## ALL INDIA INSTITUTE OF MEDICAL SCIENCES (AIIMS)

### AMENDMENT No. – I

**Project Name:** Tender for “External Electrical Works for construction of Electrical substation at NCI Jhajjar, Haryana”

**Tender No.** HSCC/AIIMS/ NCI\_Jhajjar/SS/2017; dated: 10.01.2017

TITLE  
NATIONAL CANCER  
INSTITUTE  
MASTER PLAN  
AIIMS,  
JHAJJAR CAMPUS

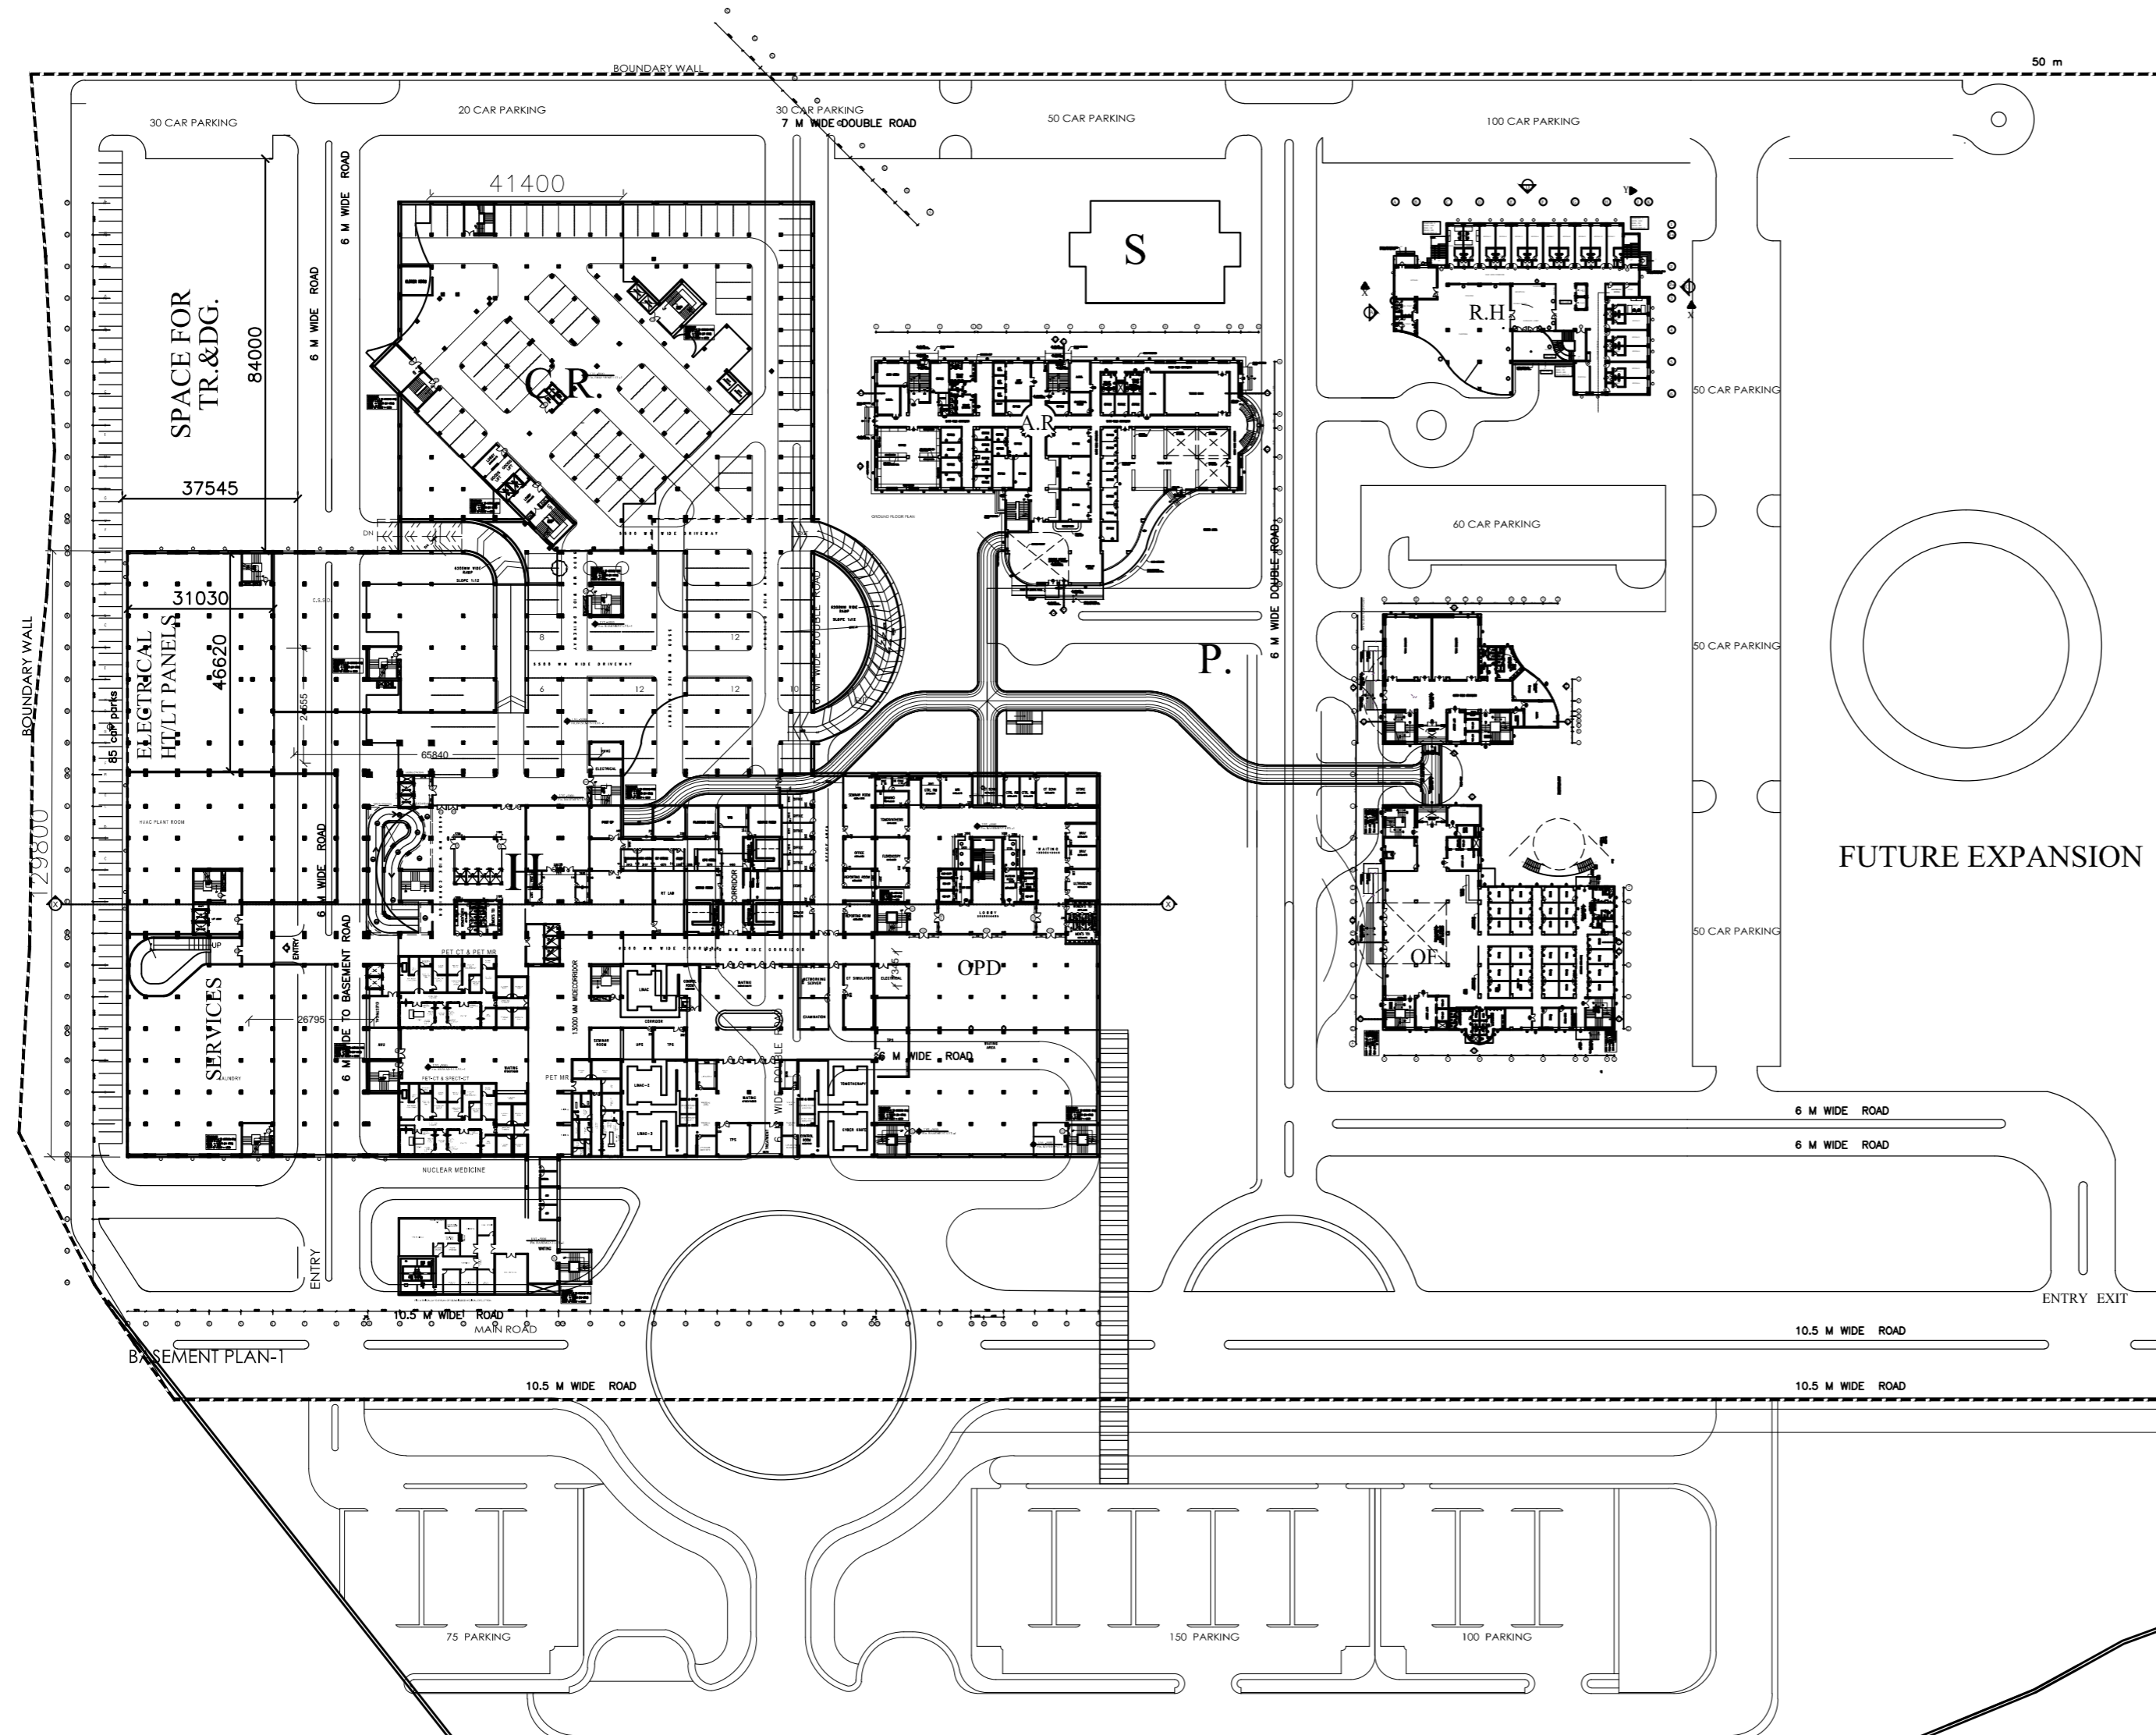
27	DG sets	Technical Specifications	8.3.5 & Page No SPEC Page E-40R1	<b>Period of Operation / Duty Cycle:</b> The set shall be capable of running at full load for not less than 300 hrs continuously or as per manufactures recommendations.	It is specified in the BOQ and other part of specification that rating is <b>Prime Power Application</b> and <b>IS-8528</b> states that for Prime Power Application " <b>The permissible average power output (Ppp) over 24 h of operation shall not exceed 70 % of the PRP unless otherwise agreed by the RIC engine manufacturer</b> " (Copy Enclosed for your reference). However, DG Sets (Prime Power Application) are suitable for running continuously 300 Hour or more at variable load. You are requested to kindly confirm your acceptance.	as per tender
28	DG sets			General	Please Provide the approx. distance between DG Set & DG Synchronizing Panel.	Location including Transformer/DG/Panels enclosed

61	VOL05BOQ	-	SUBHEAD 1: H.T. SUB STATION.	1 Set of Microcontroller based numerical relay having 4 element relay (3O/C+1E/F). Relay should have display of phase current and trip history.  1 Set of undervoltage relay and Overvoltage relay.  1 no. Phase reversal Relay.	As per OEM standard, phase reversal, over-voltage and under voltage shall be a part of main numerical relay only. Kindly confirm.	all components i.e phase reversal, over-voltage and under voltage should be the part of relay.
62	VOL05BOQ	-	SUBHEAD 1: H.T. SUB STATION.	Potential Transformers & Voltmeters in outgoing feeders.	Please clarify the purpose of Voltage transformer and Voltmeter in all outgoing feeders.	for measurement of power.
63	VOL05BOQ	04/24	1.04 BATTERY CHARGER PANEL	2 numbers battery of minimum 180 AH ampere hour capacity.	Please specify the type of battery to be considered.	Dry sealed maintenance free batteries.
64	VOL05BOQ	04/24	1.04 BATTERY CHARGER PANEL	Control cabling between DC Distribution panel to the HT panel of the Substation with suitable core 1.5 sqmm copper cable	Please specify the cable length between HT panel and DC Distribution panel.	Location including Transformer/DG/Panels enclosed

65	VOL05BOQ	05/24	1.04 BUS DUCTS :	Accessories	Please provide the layout or detailed accessories BOQ of bus duct for us to quote accordingly.	Location including Transformer/DG/Panels enclosed at <b>Annexure - III</b> .
66	VOL05BOQ	13/24	3.00 SUBHEAD 3 : DG SET & ACCESSORIES	Low side works	Please provide the detailed BOQ for DG Set Low side works.	included in respective BOQ items.
67	VOL05BOQ	21/24	4.00 LT CABLES	4.07 Flexible Cables	Please provide the technical spcification for flexible cables.	As per relevent IS code.
68	Technical Specification		5.05 (iii)/SPEC Page E-24 R1	Temperature category: -25 degree C to 70 degree C	MPP Capacitors has maximum temperature limit of 55 deg C	As per the standard of manufacturer.
69	Technical Specification		5.05 (v)/SPEC Page E-25 R1	Over current: 2.5x In	Over current should be 1.8 x In	As per the standard of manufacturer.
70	Technical Specification		5.05 (vi)/SPEC Page E-25 R1	Peak inrush current withstand: 400 x In	Peak inrush current withstand should be 250 x In	As per the standard of manufacturer.
